Access Compliance Report

Public Rights-of-Way

Intersection ID: 44780	Main Street: SESSIONS_ST	Cross Street: SILVER_CRESCENT_DR	Location: NE
ADA ID: 0D987524267B	Ramp Type: PerpDiag	Initial Pass/Fail: Fail	Overall Compliance: No
Severity Score: 12.5			
Codes/Mitigation Info/Possible Solution		Field Measurements/Component Compliance

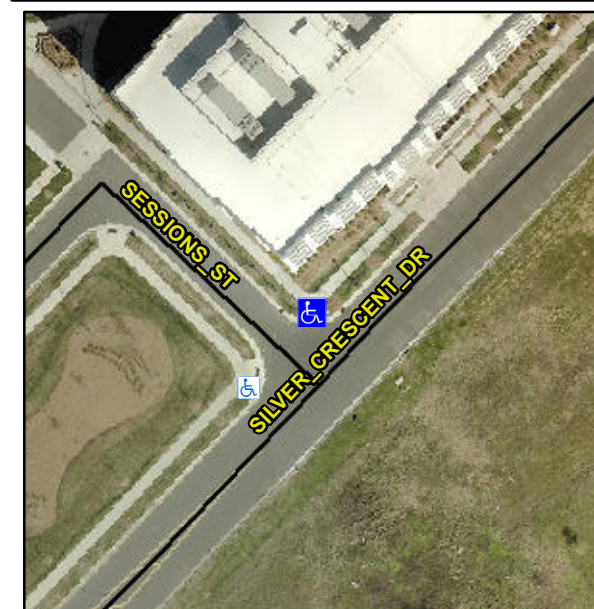
Not Found, R304.2.2

Compliance	Description	Data	Compliance	Description	Data
N/A	Ramp Length (in)	93.0	No	Ramp Slope (%)	9.2
Yes	Ramp Width (in)	60.0	Yes	Ramp XSlope (%)	1.3
N/A	Flare Type LT	N/A	N/A	Flare Type RT	N/A
N/A	Flare Slope LT (%)	N/A	N/A	Flare Slope RT (%)	N/A
N/A	Flare Traversable LT?	N/A	N/A	Flare Traversable RT?	N/A
N/A	Landing Length (in)	N/A	N/A	DWS Provided?	N/A
N/A	Landing Width (in)	N/A	N/A	DWS Contrast?	N/A
N/A	Landing Slope (%)	N/A	N/A	DWS Length (in)	N/A
N/A	Landing X Slope (%)	N/A	N/A	DWS Full Width?	N/A
N/A	Landing Curb? (Y/N)	N/A	N/A	DWS Offset (in)	N/A
N/A	Shared Landing?	N/A			
N/A	Gutter Ponding?	N/A	N/A	Gutter Slope (%)	N/A
N/A	Gutter Lip Ht (in)	N/A	N/A	Gutter X Slope (%)	N/A
N/A	Painted X Walk1?	No	N/A	Painted X Walk2?	No
	X Walk 1 Direction	To SW		X Walk 2 Direction	To SE
N/A	X Walk 1 Width (in)	N/A	N/A	X Walk 2 Width (in)	N/A
	X Walk 1 Slope (%)	1.1		X Walk 2 Slope (%)	4.2
	X Walk 1 X Slope (%)	1.9		X Walk 2 X Slope (%)	0.3

Remove & Replace Curb Ramp With Two New Directional Ramps or Equivalent.
